Re: Lorencito Canyon Mine (Permit No. C-1996-084)

Preliminary Adequacy Review of Permit Renewal Application No. 5 (RN-5)

Figure 1. Areas where rills, gullies and sparse vegetation has been found to be a persistent problem at the site are within the dotted circle areas. Background image is the 2020 annual report map.

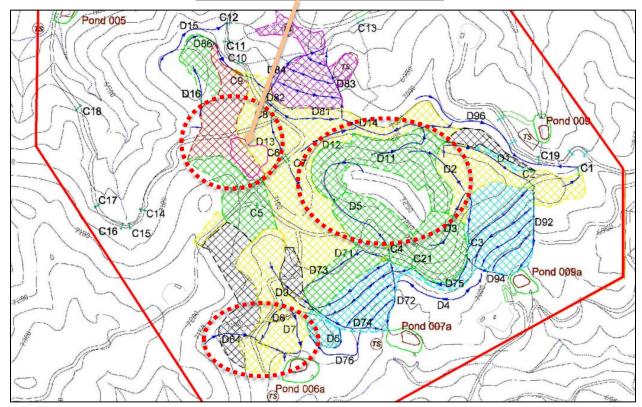
11. Significant rills, gullies, and areas with sparse vegetation have been noted in the reclaimed areas around the "Knob", areas reported to have been reclaimed in 2006 and 2005 located above the area where pond and ditch cleanings are being stored, and areas reported to have been revegetated in 2007/2004 above Pond 006a. These areas are shown in the figures below. NECC has utilized several erosion control methods including the placement of straw waddles perpendicular to some of the eroded slopes, and the placement of brush within rills and gullies. The brush does seem to help prevent the rills from growing, and the brush seems to catch and hold soil and growth medium. Given the age of the reclamation of these areas in question, NECC will need to evaluate these areas to determine the best methods to fill, regraded, or otherwise stabilized these areas from erosion in accordance with Rule 4.14.6. Also, it is likely these areas will need to be reseeded in places given the sparse nature of the vegetation that has established. Please update the rill and gully plan to address how these areas will be stabilized in accordance with Rule 2.05.4(2)(c).

- 12. NECC has placed the sediment they have cleaned from the various sumps and ditches in an area northwest of the "Knob" in an area previously reported to have be seeded in 2004/2005 based on the 2020 annual reclamation report map. Page 2.05-30a of the Permit Application Package (PAP) provides a plan for the handling of sediment cleaned from Pond 009 to be placed in a "drying area" and then used for mine reclamation as determined by a soils analysis. PAP page 2.05-33 provides a general plan for handling sediment cleaning from ponds. Please clarify the plan for handling all material/sediment cleaned from all the sediment control structures as this is not clearly discussed in the PAP.

- 13. The stockpile area used for sediment drying discussed above has been re-affected by the stockpile activity and therefore cannot be considered to have been reclaimed in 2004/2005 as portrayed in the annual report maps. NECC will need to adjust the annual reclamation report to account for this area being re-affected. Please submit a revised annual reclamation report form to account for this area.
